Re: HTC 23229/24837 Autumn Parc Material Amendment Request

RE: Autumn Parc
1915 & 1921 W. Arkansas Lane
Arlington, Texas 76013

SITE PLAN

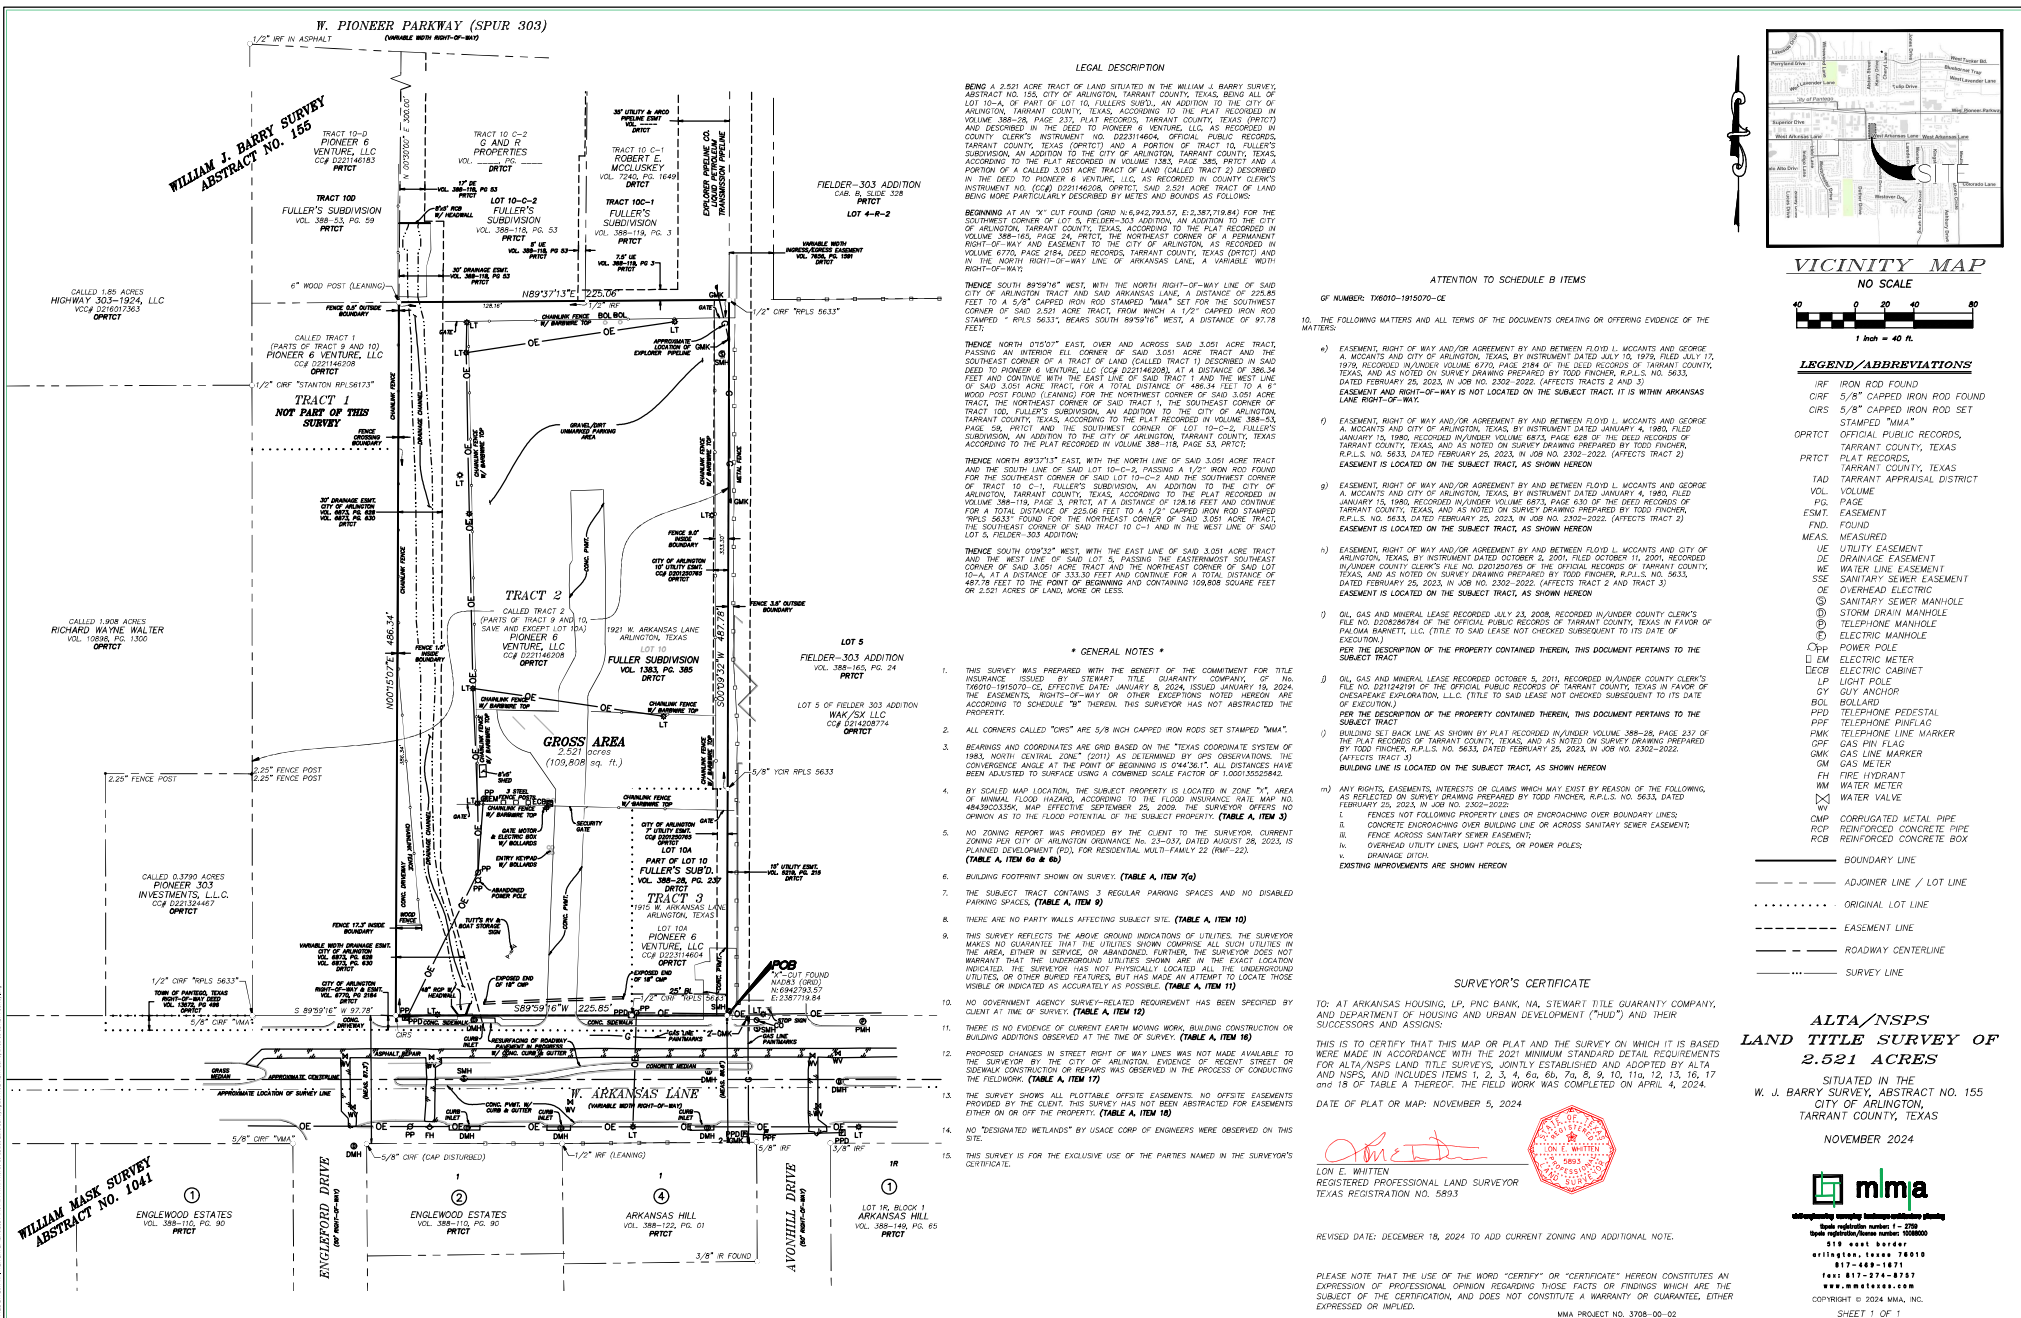
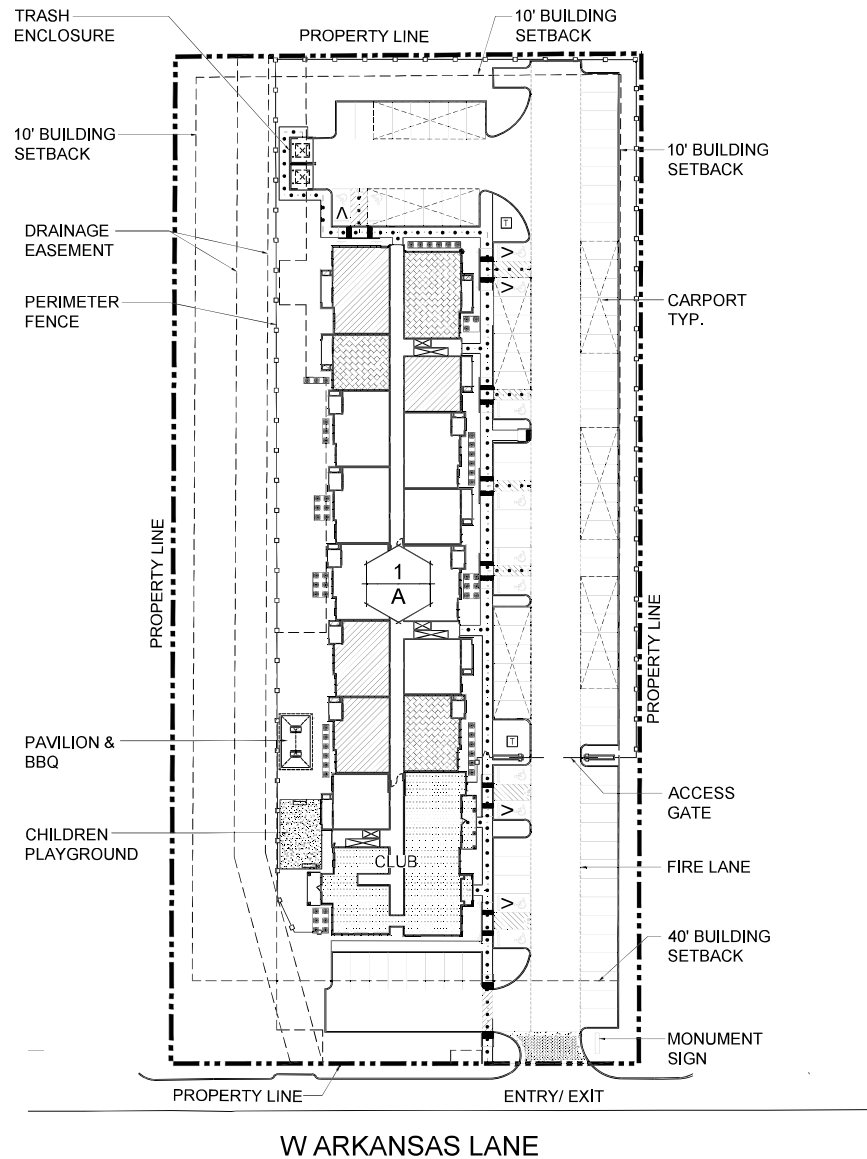
At application, Autumn Parc was proposed to have 57 total units with a detention area at the northwest corner of the development site. During the site plan review process, the City of Arlington required a comprehensive drainage study and then required a detention system to mitigate *both* the development's drainage *as well as* drainage for adjacent properties. Due to limited space on the development site, an underground detention system would be required. The developer submitted five full drainage plan submittals and worked through comments with the City of Arlington from 2024 through July 2025; however, the City continued to express concerns about the underground detention system citing limited experience with the proposed design and materials. During preparation of a sixth submittal, alternatives to an underground detention system were discussed, and the City indicated that the site plan submitted with this amendment request—with detention in a wide drainage channel along the western side of the development site—would be acceptable and eliminate the need for underground detention.

In order to accommodate the wide drainage channel, the development, originally proposed with 57 total units in 2 buildings, is now proposing 51 units in 1 building. At application, 12 of the 57 units were market rate, and the 6 units being eliminated were market rate units. This amendment proposes no change to the total number of low income units from application: there will be 45 low income units and 6 market rate units. The residential density at application was 22.18 and the residential density with this amendment at 2.521 acres is 20.23.

At application, the development had 57 units; 15 one-bedrooms, 24 two-bedrooms, and 18 three-bedrooms. This amendment proposes 51 units with 15 one-bedrooms, 26 two-bedrooms and 10 three-bedrooms. The NRA has been reduced from 55,110 to 47,716.

Common area has been reduced. At application, there was 12,736 square feet of common area, which included breezeways and 3,371 sf in the clubhouse area. This amendment proposes 10,769 of common area, which includes breezeways and tenant areas of the clubhouse. Parking has also been reduced from 119 total spaces at application to 102 total parking spaces, corresponding with a reduction in total units.

Therefore, an alternative site plan has been proposed to include a drainage channel on the western boundary of the site. This drainage channel is an acceptable solution for the City of Arlington. The new site plan will remove the need for an underground storage system, but will require the reduction in units from 57 to 51 in order to allow for the area needed for the drainage channel.
